Per engineering regarding the issue with your spinner, and we found that the issue is not with the spinner itself but with the amount of clearance the spinner has on the bracket that houses the spinner.

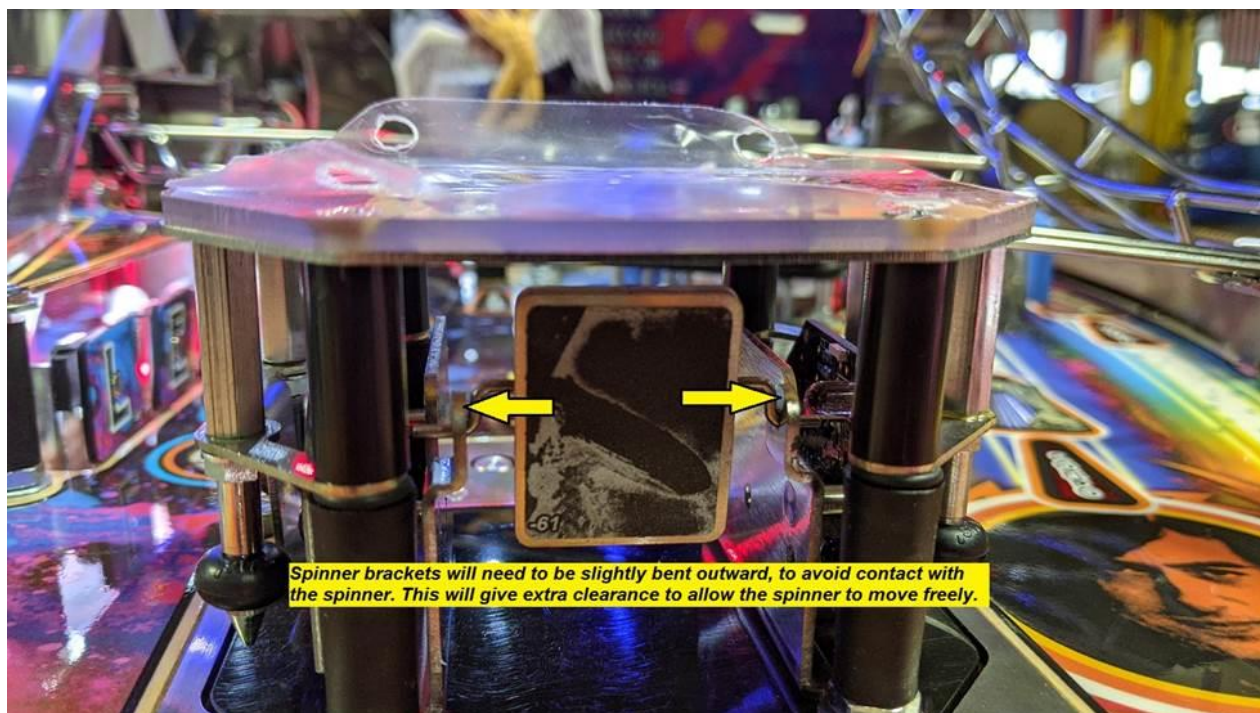
Spinner brackets will need to be bent outward, to avoid contact with the spinner. This will give extra clearance to allow the spinner to move freely.

The remedy is to use a pair of needle-nose pliers and slightly bend the brackets outward in order to allow for extra clearance.
